**NOTICE OF MEETING**

May 2, 2012  
Village of Babylon Board Room  
153 West Main Street  
Babylon, NY 11702

Staff Report  
The Hamptons Club @ Eastport  
Municipality: Town of Brookhaven  
Addendum 5/2/2012  
Referral received: 4/16/12  
Jurisdiction: NYS Rte. 27, CR 111, Pine Barrens

Z-1: The Hamptons Club @ Eastport  
 SCPD: BR-12-02  
 SCTM No: 0200-563.00-05.00-001.001 et al.

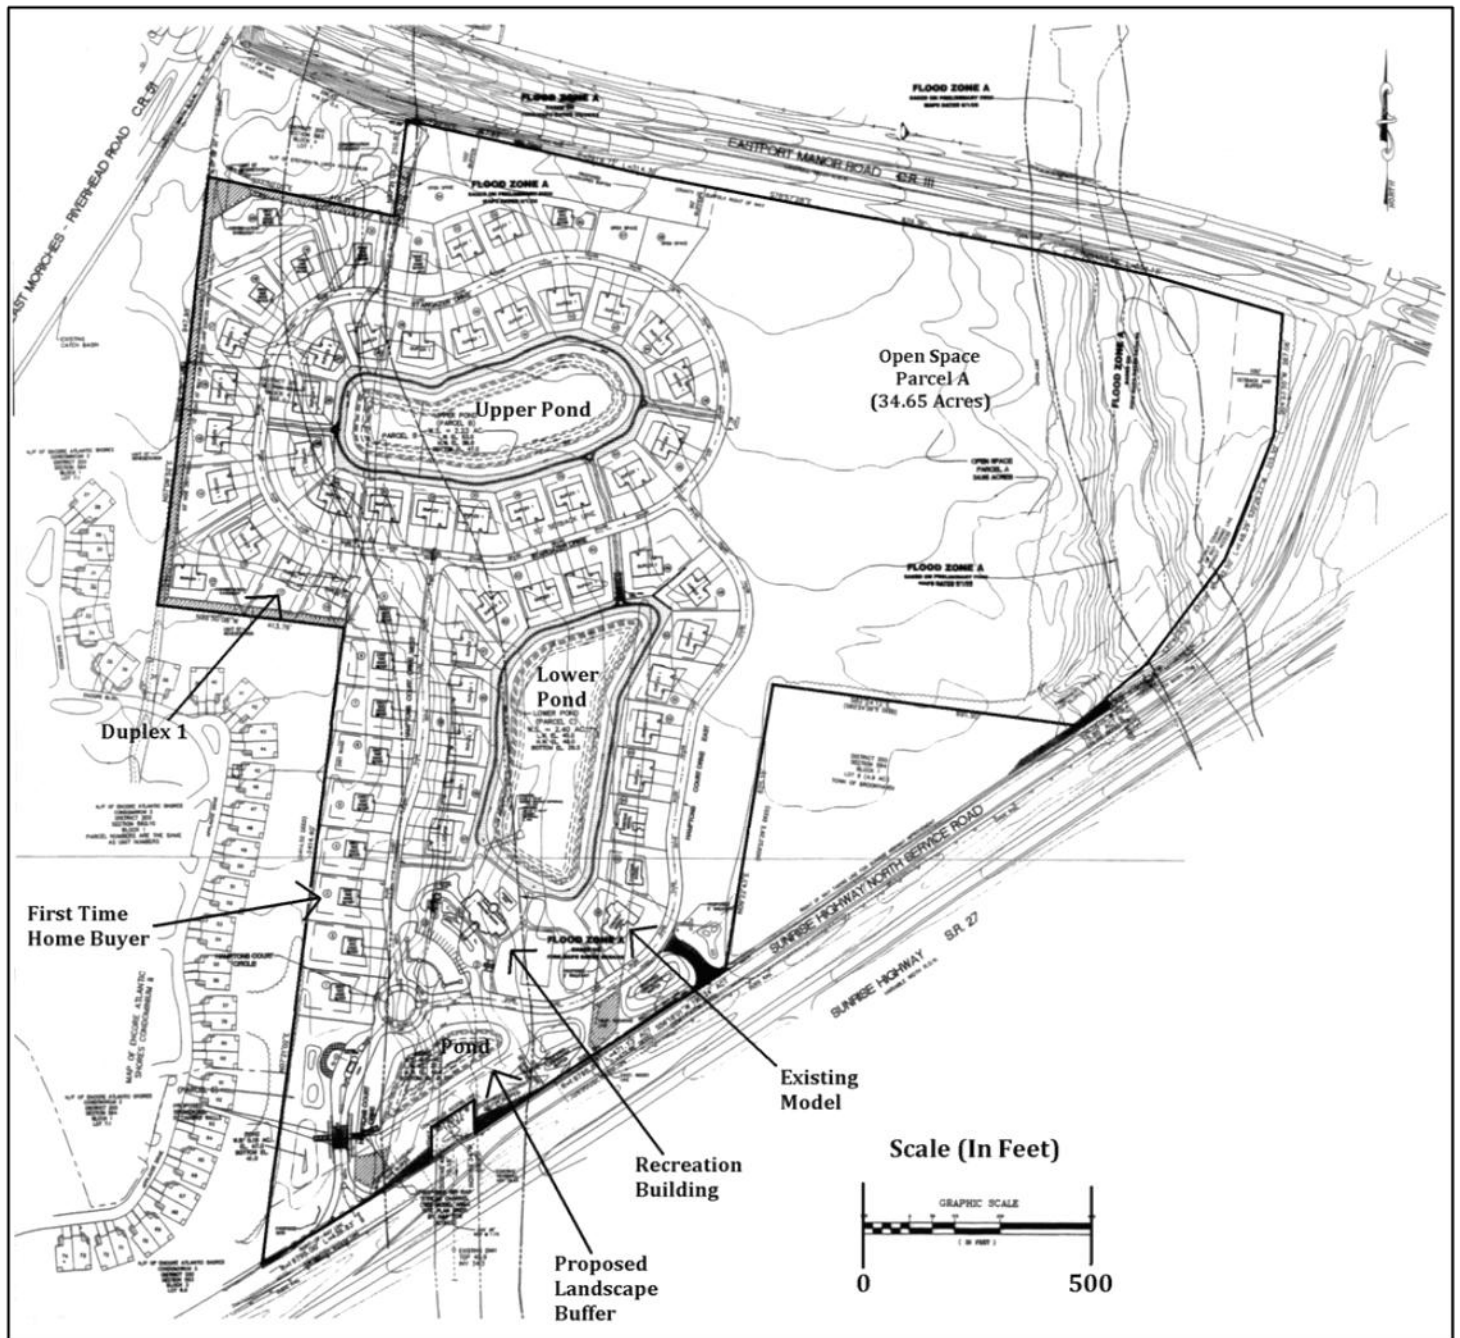
From the nature of the referral material the applicants have given some consideration to the contents of the Suffolk County Planning Commission Guidebook. The subject application is in conformance with environmental protection goals as established by the Central Pine Barrens Plan and Article 6 of the Suffolk County Sanitary Code. The subject application is responding to economic conditions and by its very nature is economic development. The attached unit residential nature of the proposal provides for housing diversity in this area of Eastport. The proposal for attached residential housing includes 30 affordable units and represents approximately 25% of the total number of units.

1. The applicants should investigate with the Suffolk County DPW Transit Division, possible accommodations for bus riders.
2. The applicants should review the Suffolk County Planning Commission Guidebook particularly related to conservation of energy and public safety and incorporate where practical design elements recommended therein.

Z-2: The Hamptons Club @ Eastport  
 SCPD No.: S-BR-04-13.1  
 SCTM No.: 0200-563.00-01.00-005.001 et al

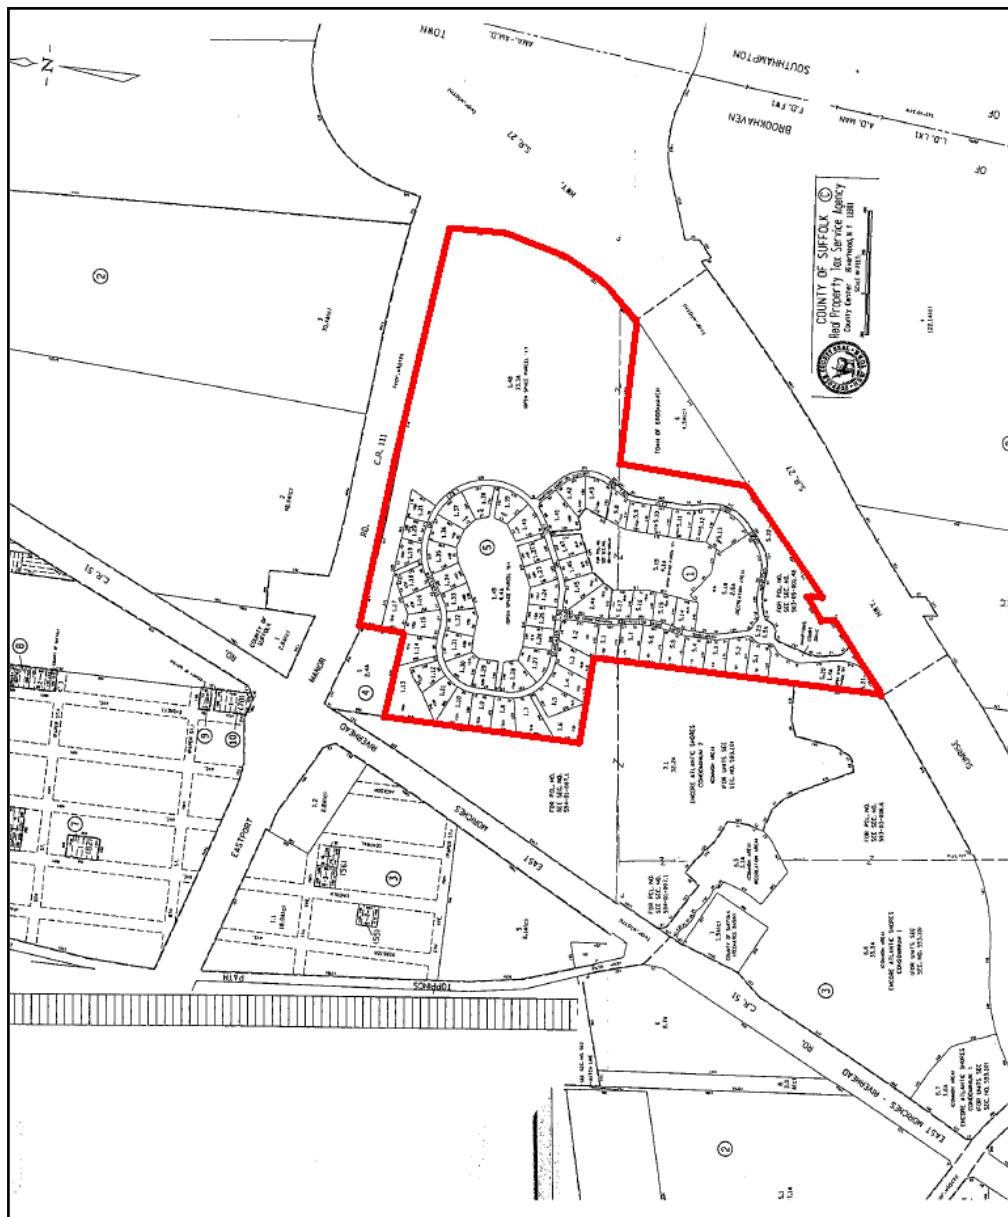
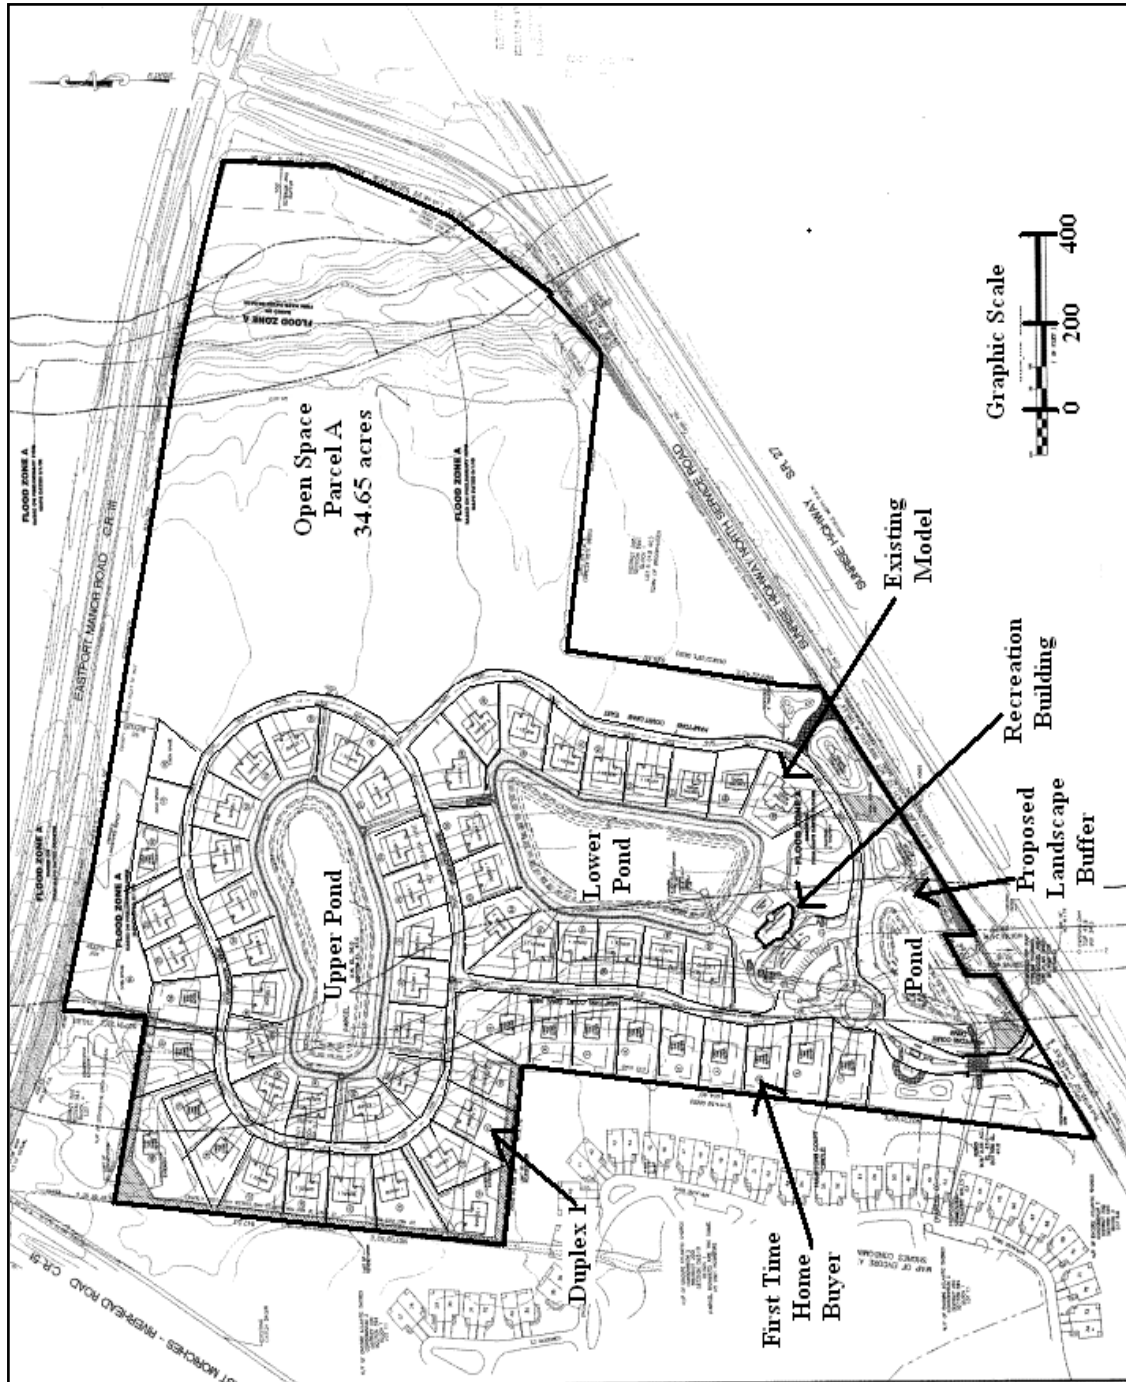
- 1) The change of zone proposes to transfer wastewater credits from outside of the Central Pine Barrens to the subject parcel. This is contrary to the intent of The New York State Pine Barrens Protection Act and the Central Pine Barrens Land Use Plan and threatens an important regionally significant groundwater resource.
- 2) The proposed change of zone for increased residential density is not consistent with Suffolk County Planning Commission policy that states that increases in residential density should be in close proximity to downtowns, hamlet centers and in areas with convenient access to commercial and community services and public transportation.
- 3) The proposed change of zone for increased residential density is not consistent with Suffolk County Planning Commission's environmental policies including the specific

policy to promote development where it is warranted in downtowns, hamlet centers, adjacent to transportation and retail services and discourage development where it is not warranted within coastal zones, environmentally sensitive areas such as the Pine Barrens, unique ecological habitats and designated open spaces.

Z-2: Cedar Pines Senior Care  
 SCPD No.: BR-10-04.01  
 SCTM No.: 0200-793.00-01.00-013.000 et al.

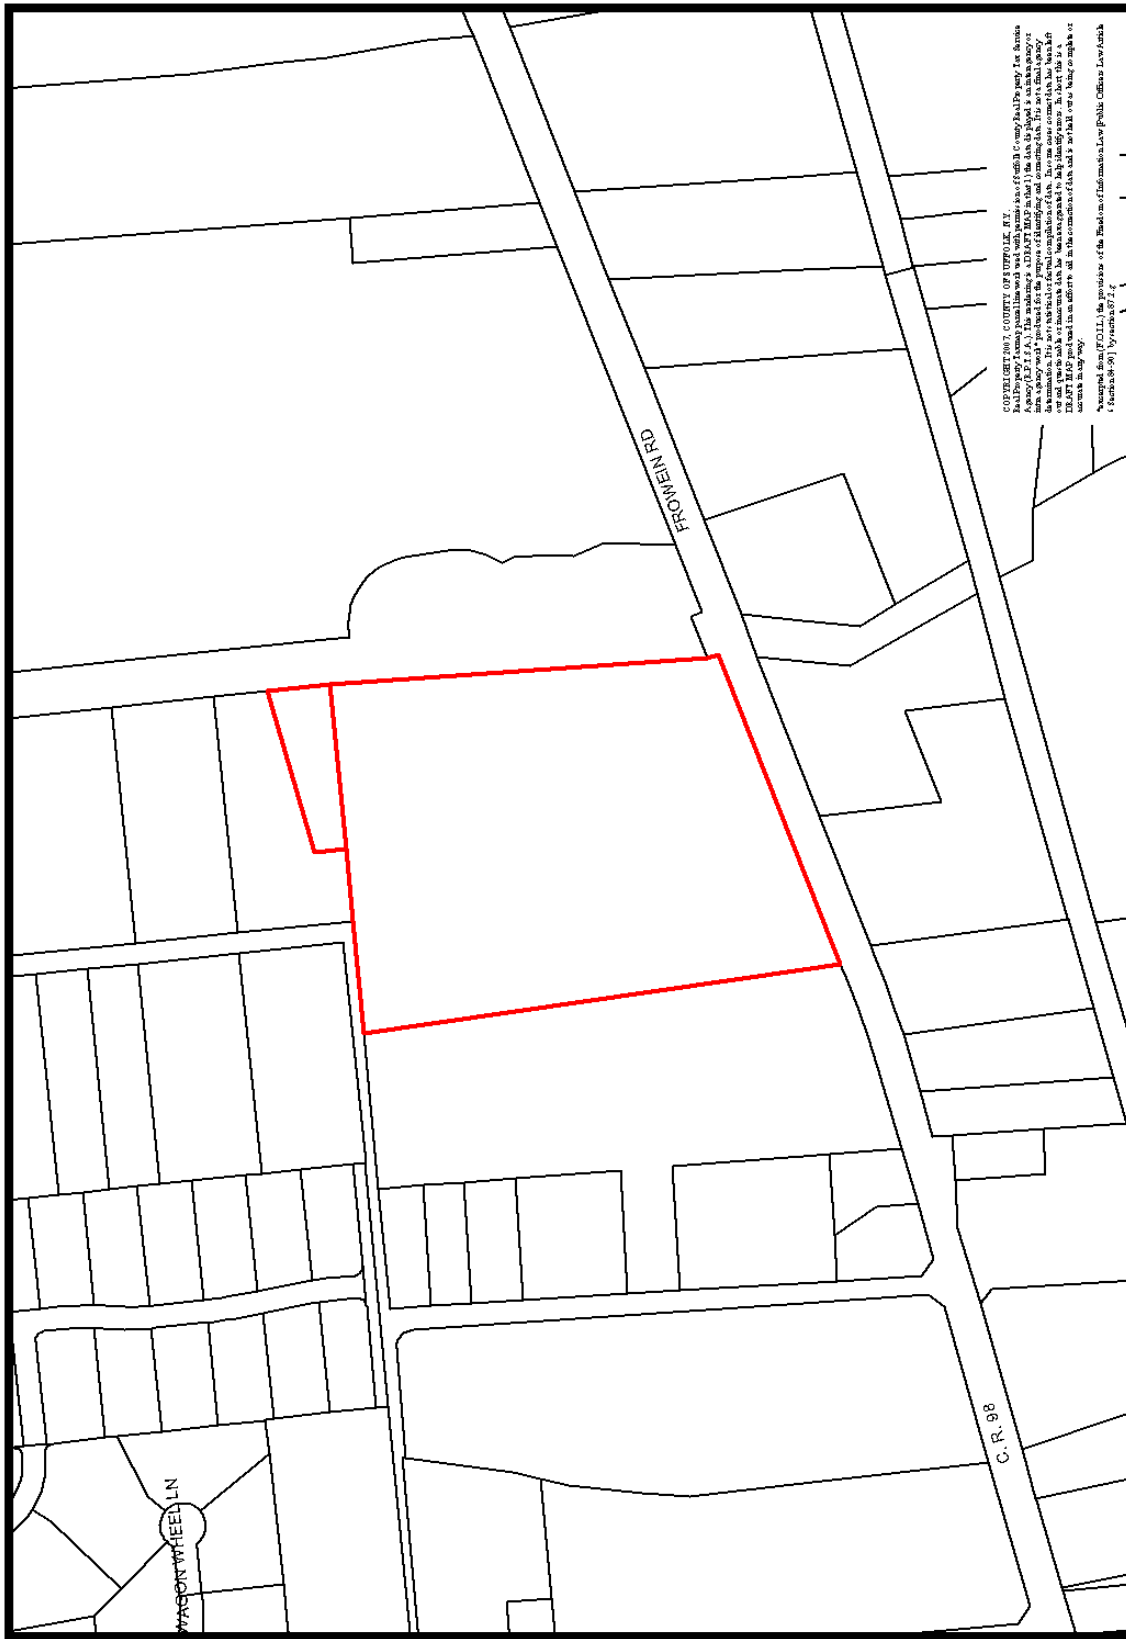
1. Applicants should continue dialogue with the Suffolk County Department of Public Works regarding improvement and access to CR 98 and seek all appropriate approvals.

2. In addition, the applicants should investigate with the Suffolk County DPW Transit Division, routing Suffolk County Transit bus service to a convenient location within the subject property and or the petitioner make available to the residents a shuttle/van service to commercial and community services.

3. Petitioners should continue the dialogue with the Suffolk County Department of Health Services regarding off site connection to the adjacent STP.
4. The applicants should review the Suffolk County Planning Commission Guidebook particularly related to conservation of energy and public safety and incorporate where practical design elements recommended therein.

5. The most landward limit of wetland vegetation last flagged in the field by a qualified expert (12-10-2009) should be verified by the appropriate regulatory agency and the line (properly notated) should be represented on all sketches, plans, maps, etc.

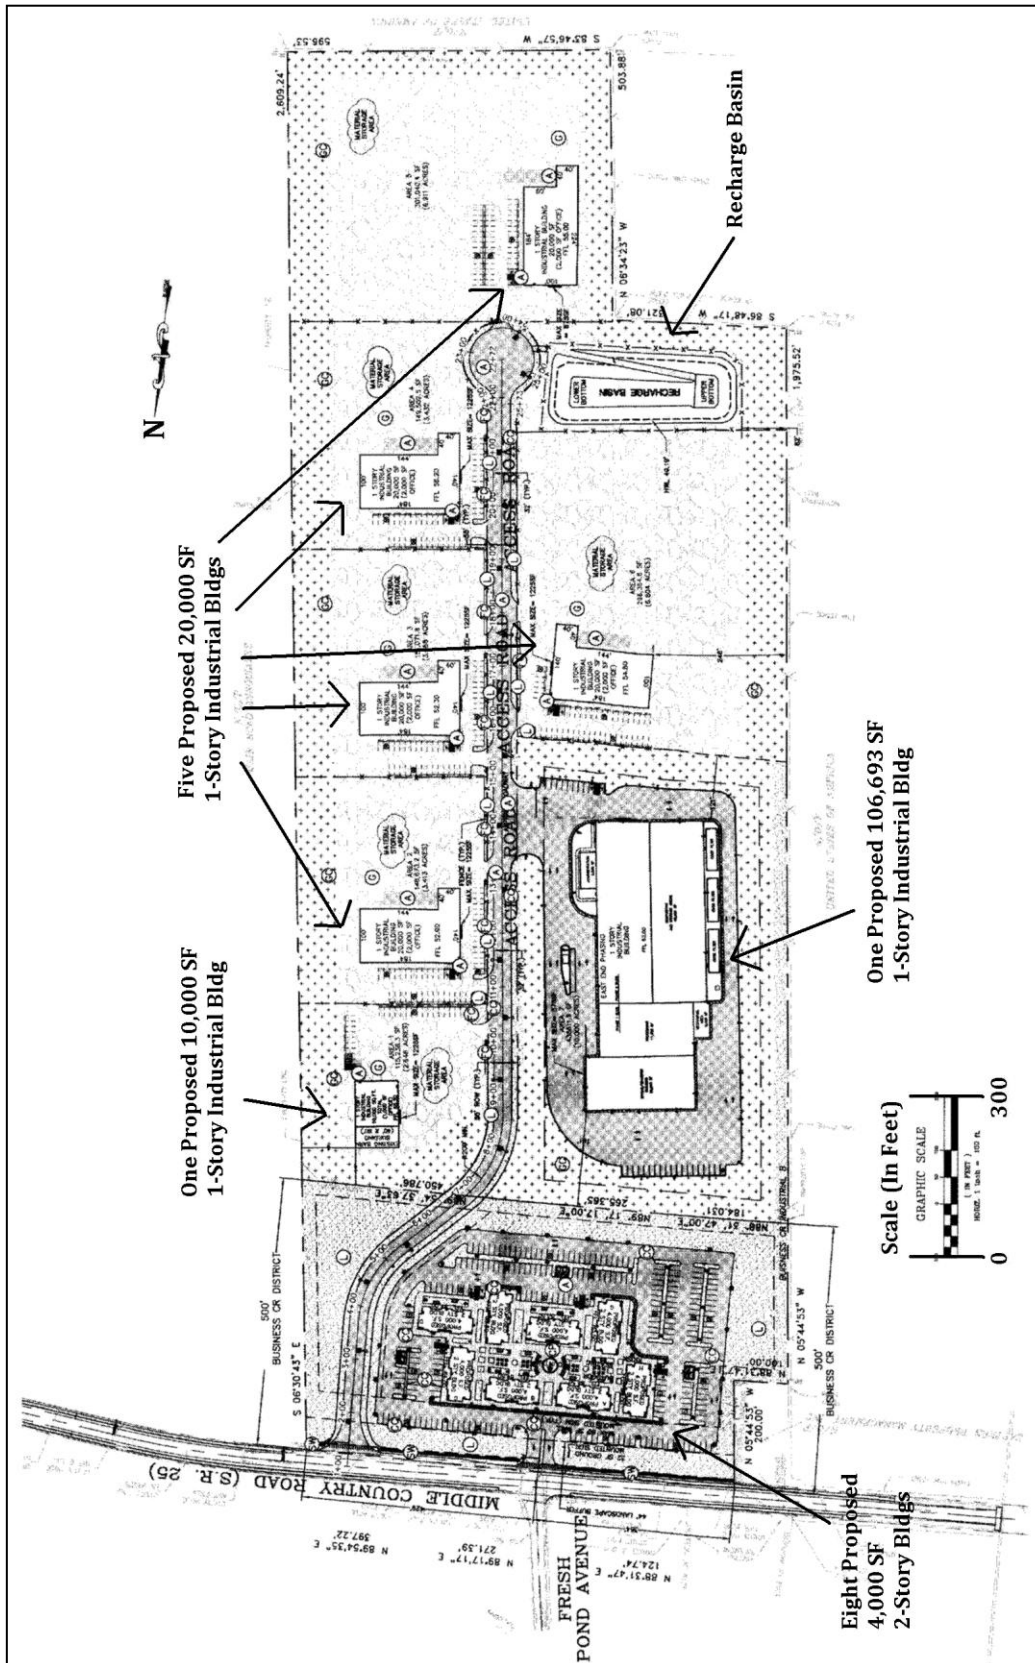
1. Applicants should contact the NYS Department of Transportation and seek all appropriate approvals.
2. The applicants should investigate with the Suffolk County DPW Transit Division, possible accommodations for bus riders particularly related to the commercial/residential component of the plan.

3. There is no emergency access proposed for the either component of the site plan. An emergency access should be provided between the commercial component and the industrial component.

5. All storm water runoff should be kept on site and treated in accordance with best management practices. The applicant should be encouraged to review the Suffolk County Planning Commission publication entitled *Managing Stormwater-Natural Vegetation and Green Methodologies* though the applicants have already proposed the use of rain gardens for storm water management.

6. The applicants should review the Suffolk County Planning Commission Guidebook particularly related to conservation of energy, public safety, and storm water management and incorporate where practical design elements recommended therein.
